Reliability Analysis Update PJM – Mid-Atlantic

Subregional RTEP Committee – PJM MA

1/15/2025

b3737.24 and B3737.25 Cancellation: Cardiff – Lewis 138kV

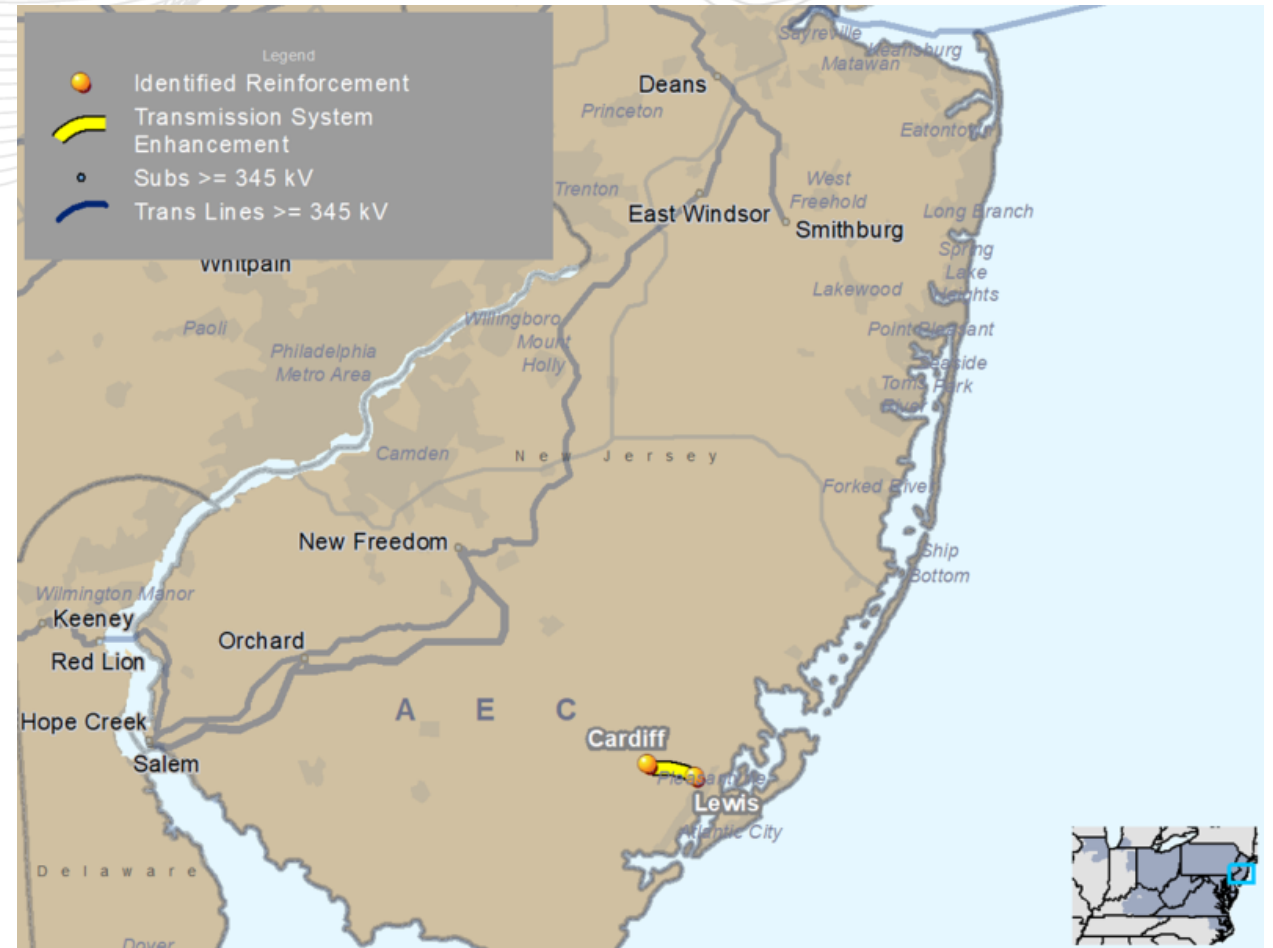
B3737.24 and B3737.25 were identified part of the NJ OSW SAA 1.0 study

- **b3737.24:** Upgrade Cardiff-Lewis 138 kV by replacing 1590 kcmil strand bus inside Lewis (\$0.10M)
- **b3737.25:** substation Upgrade Lewis No. 2-Lewis No. 1 138 kV by replacing its bus tie with 2000 A circuit breaker (\$0.50M)

The B3737.24 and B3737.24 were identified to address an N-2 violation.

Cancellation Reason: facility inspection has confirmed that the limiting element that was associated with this upgrade, was not the limiting element, and so the facility ratings has been corrected accordingly, and the upgrades are no longer needed.
